Subject: Submittal of Revised Inspection and Maintenance of Erosion Controls Associated with Fishladder Canyon [Solid Waste Management Unit 16-003(o)] and Response to Review of the Inspection and Maintenance Report

**Response to the Review of the 2015 Inspection and Maintenance Report of Erosion Controls
Associated with Fishladder Canyon [Solid Waste Management Unit 16-003(o)],
EPA ID# NM0890010515 HWB-LANL-15-062
Dated January 13, 2016**

Figure 3 View looking upslope at the former fishladder location (11/04/2015). Straw wattle (V007030600028 - located in the upper third of photo) is hidden by established vegetation. Condition of controls – very good.

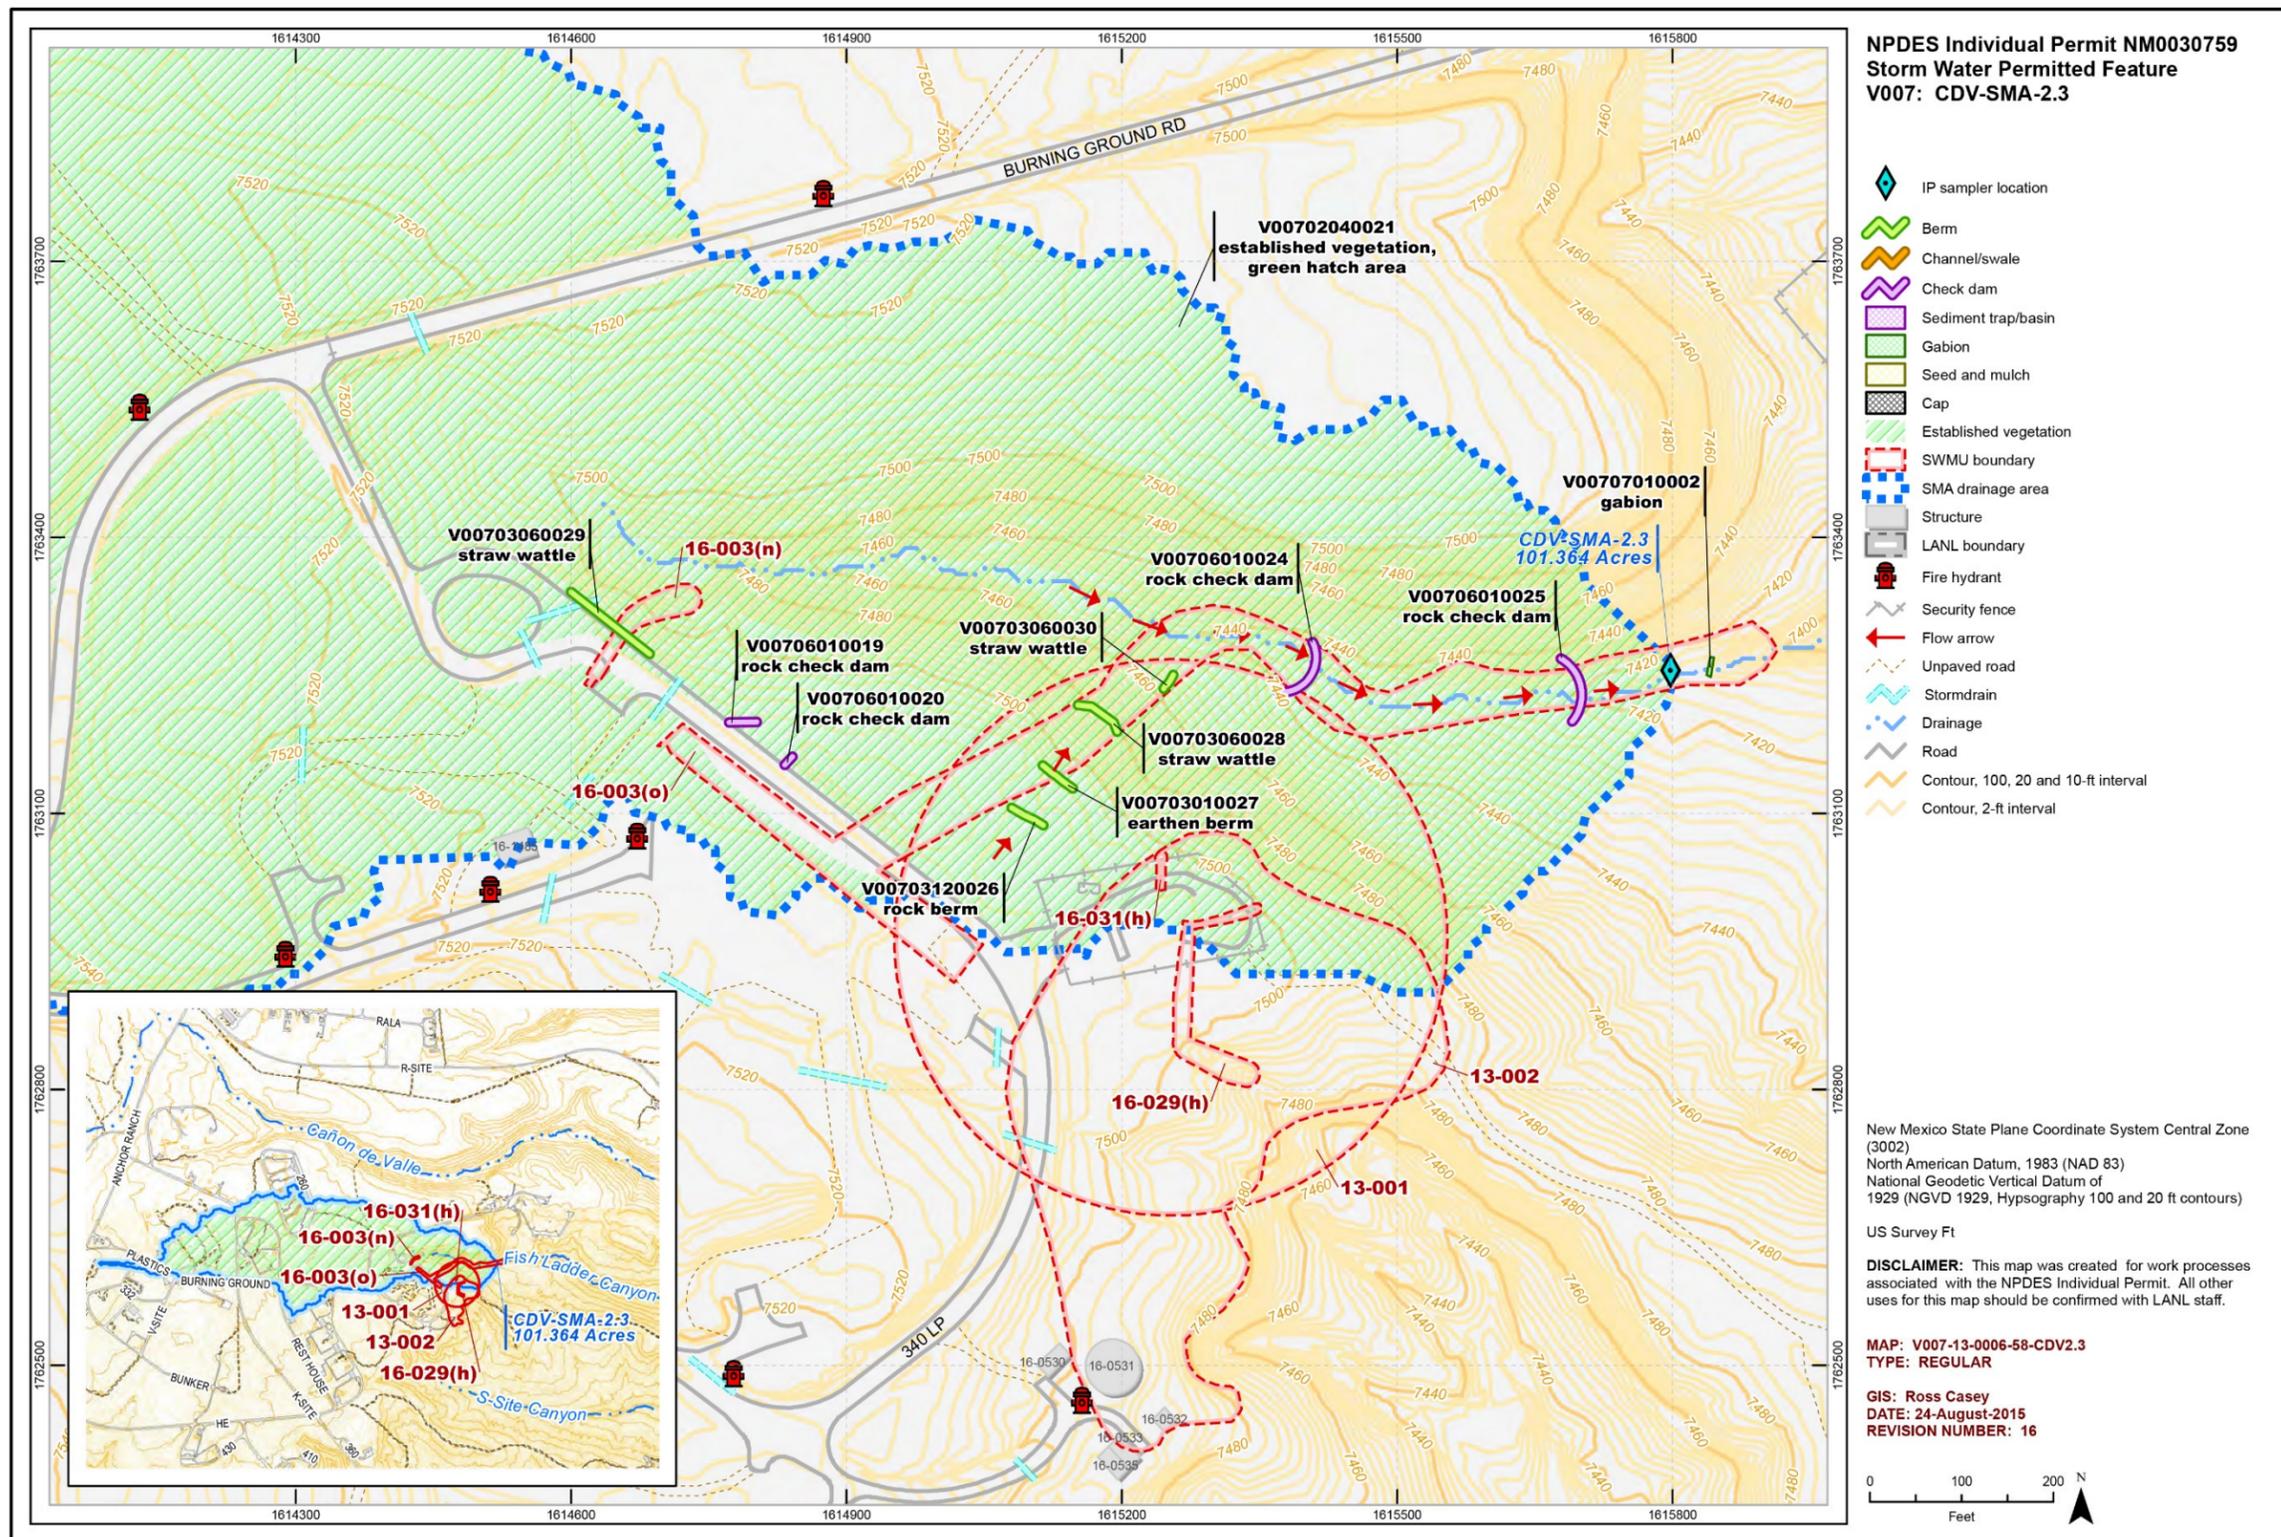
1. *The Permittees follow-up inspection on November 4, 2015, "determined the area below straw wattle-0028 is stable and well vegetated. No additional action needs to be completed" is not supported by the documentation and figures provided, for example the straw wattle described is not visible in the photograph and the Permittees did not provide additional photos of the area demonstrating vegetative health. Provide additional photographs of the area below the wattle demonstrating vegetative health, as well as a summary of the criteria used to determine slope stability in the area.*

3. *The text for Figure 3 describes the view of looking upslope of the straw wattle-0028 as being in the middle of the photo, but it is not observable in the photo. Please describe this image to clarify the previous location of the straw wattle-0028 or explain that the straw wattle is no longer visible due to damages originally observed during the October 28, 2015, inspection.*

1. The annual erosion evaluation under the Individual Permit was completed on October 28, 2015. Inspection findings recommended replacing the straw wattle (V007030600028); a follow-up inspection was completed on November 4, 2015, and determined the area below wattle -0028 is stable and well vegetated, as shown in Figure 3. Note that the wattle is not visible because of the vegetative cover (grasses). Figure 4 shows the vegetated slope from the intersection with the canyon drainage. Based on the established vegetative cover, lack of erosional features, and best professional judgment, no additional action needs to be completed.

Note: Figure 3 text has been updated (see response number 3), and an additional figure, Figure 4, has been added for further clarification. Figure numbering has been updated.

3. Figure 3 shows a view looking upslope at the former fishladder location on November 4, 2015. Straw wattle V007030600028, located in the upper third of photograph, is hidden by established vegetation.
